Note to editor/reviewers. Plain text represents the original comment, and bold text represents the response.

Reviewer 2:

Excellent, comprehensive analysis of debris flow activity after a fire. Findings reveal how well USGS operational models for debris flow rainfall thresholds and debris flow volumes perform for this fire location. Writing is clear, and figures are a nice combination of quantitative data and photos. My comments are mainly minor points of clarification.

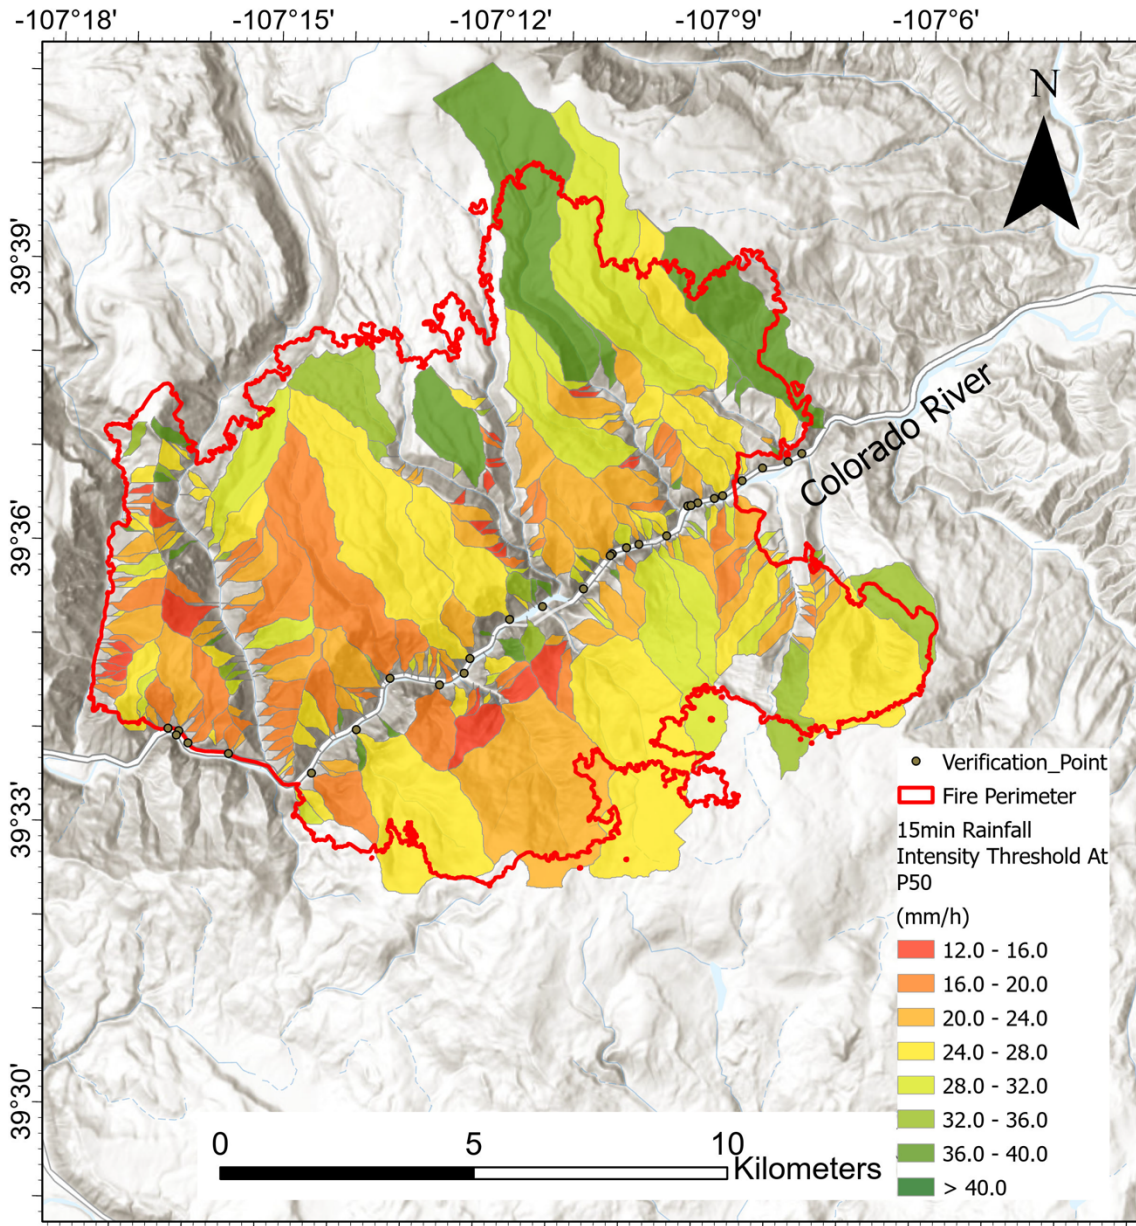
6. Figure 1: I would have found it helpful to see the locations of debris flows on this figure rather than on a separate figure.

Good Suggestion. I have now added the locations of the debris flow points to Figure 1. I didn't remove them from Figure 2, as I think they are useful reference points in both figures. I also changed what I was showing in Figure 1 to something more relevant. Instead of showing the likelihood for debris flow initiation given a 15-minute rainfall intensity of 24 mm/hr, I am now showing the 15 minute rainfall intensity threshold assuming a 50% likelihood of debris flow initiation. The median value from all of these basins is used to estimate the Year 1 firewide threshold. I have also updated the caption to reflect this:

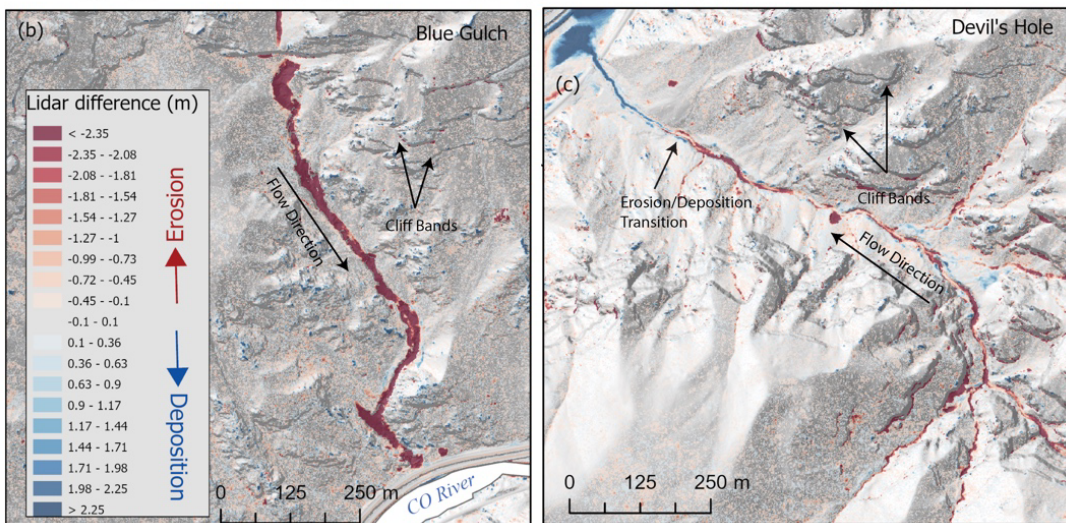
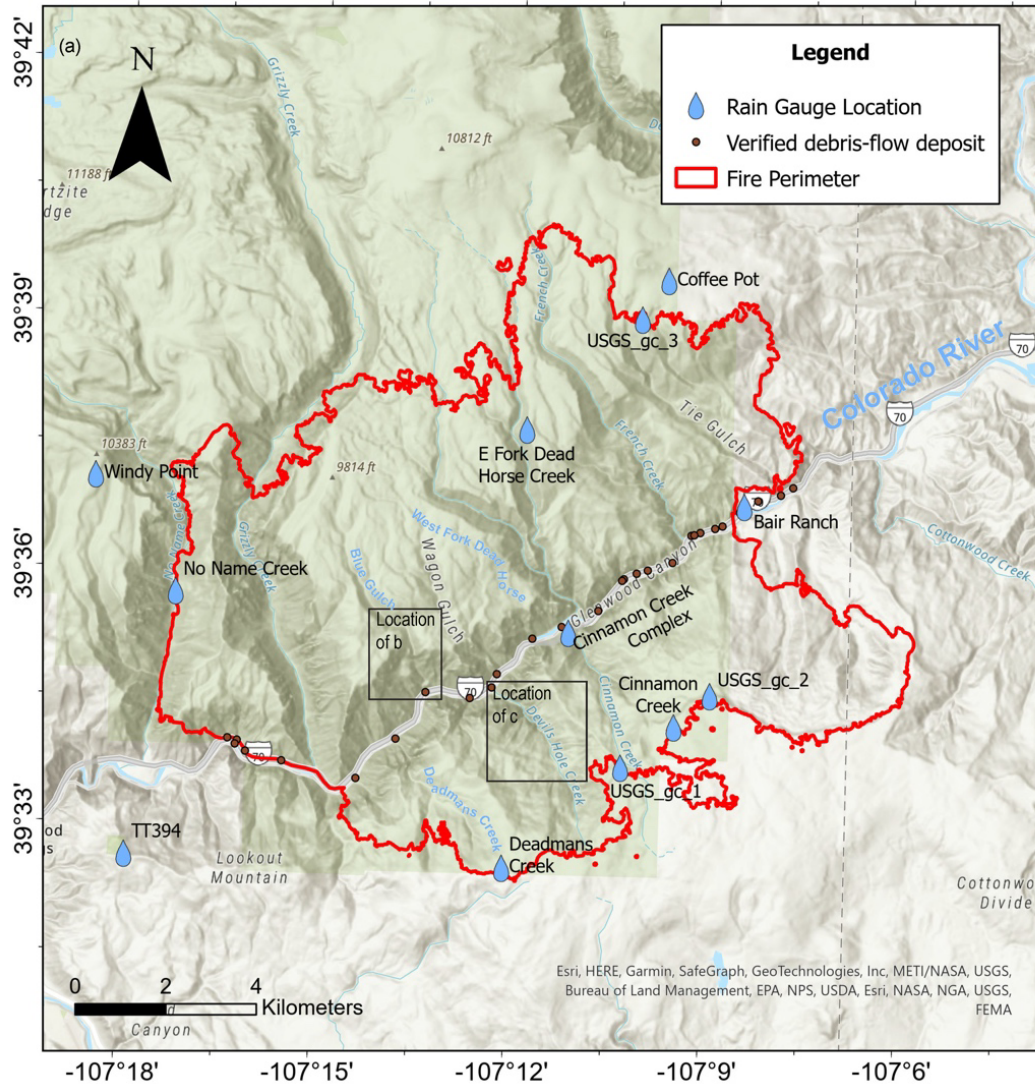
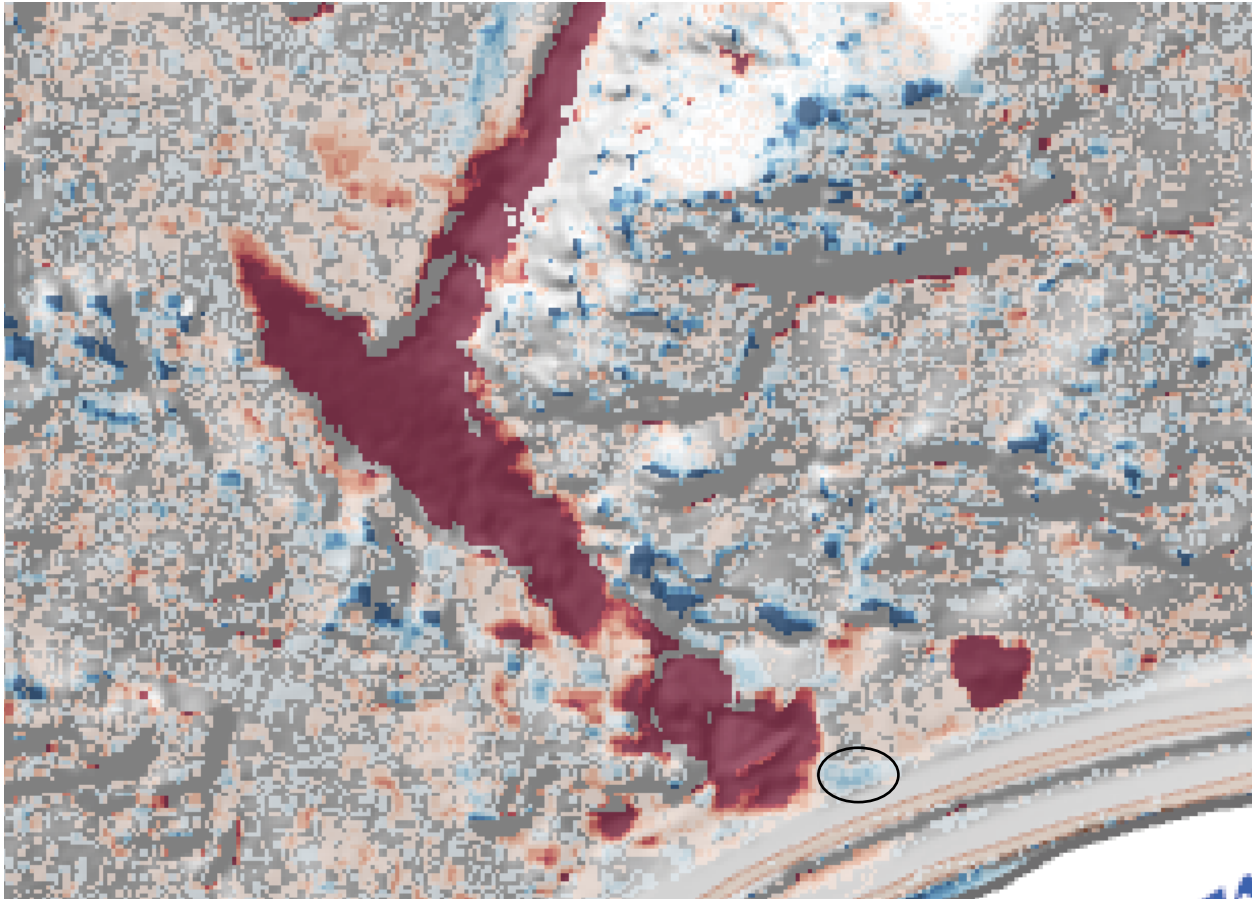
7. Figure 2b: I am not seeing deposition at the end of this debris flow track. For both b and c, consider adding an arrow to show flow direction.

I've now added an arrow to show flow direction on Figure 2b and 2c. As far as not seeing the deposition, this is a little hard it shows up more clearly in Figure 3. For the reviewer, I have illustrated this below. There is a small blue spot to the right of the red erosion. I've zoomed in and I added a black circle to indicate the deposition location for the reviewer. For the readers of the paper, I think they can see this most clearly in Figure 3a and 3c.

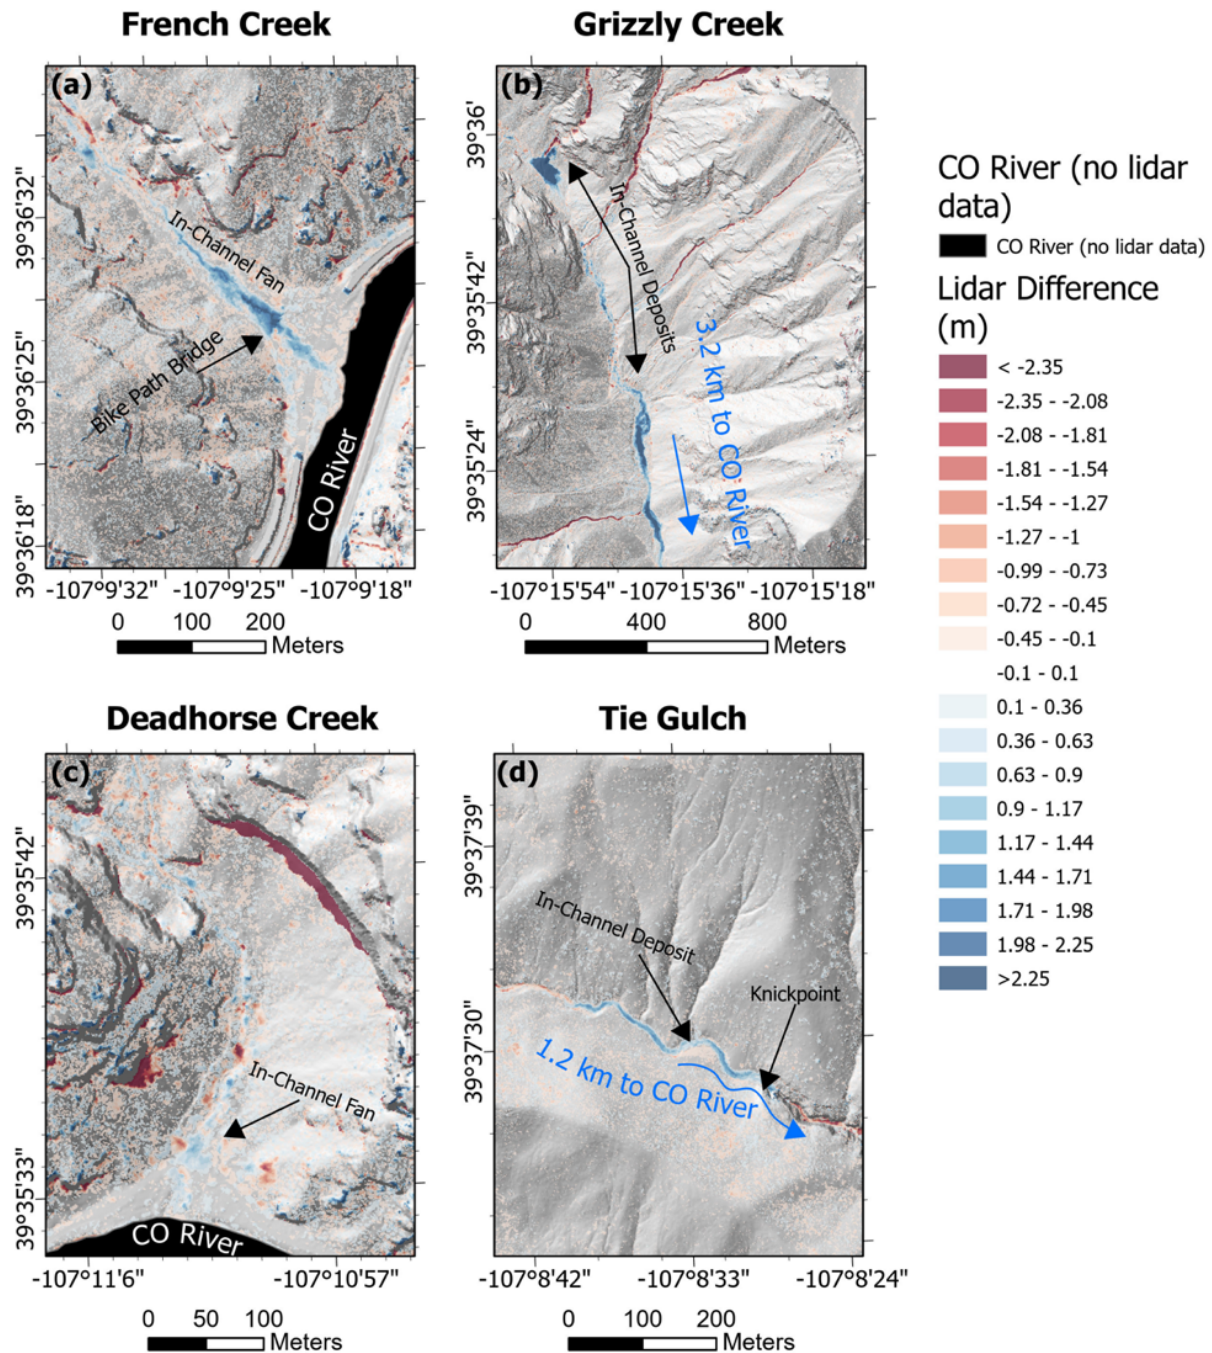
8. Figure 5d: this doesn't look like a fan - just in-channel deposition?

Good point. I have changed the figure to say “in-channel deposits” and adjusted the text throughout.

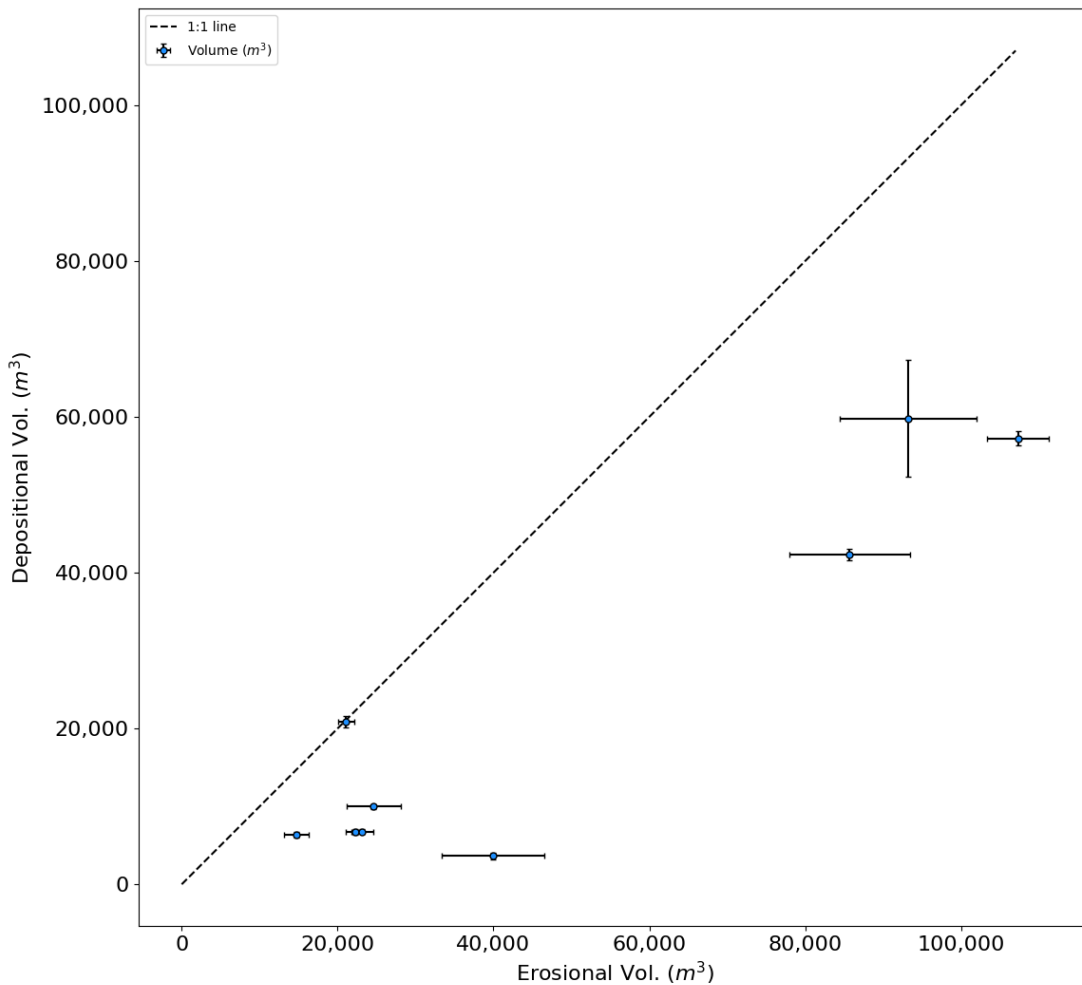
9. Figure 7: this is a nice figure but kind of a lot to take in. I am curious about how the erosion and deposition volumes compare at sites where both of those measurements were collected, but it's hard to evaluate that in this figure - could erosion-deposition comparison be pulled out as a separate figure or subplot? Then just show erosion in this plot? Do each of the debris flow volume points correspond with a rain intensity point in the bottom graph? Could be useful to have a volume vs. intensity plot, as an alternate way to visualize the data.

This is a really useful comment. Based on this comment I have created a new figure that I have added to the supplement to show erosion versus deposition, and I've added in the uncertainty in both erosion and deposition. I will add this in as a new supplemental figure. Here's a note to the reviewer that I will put in the caption. Many channels contributed to an in-channel deposit in Grizzly Creek, but for the purposes of comparing erosion and deposition, all of the erosional channels contributing upstream of the deposit were summed to compare with the deposit volume.
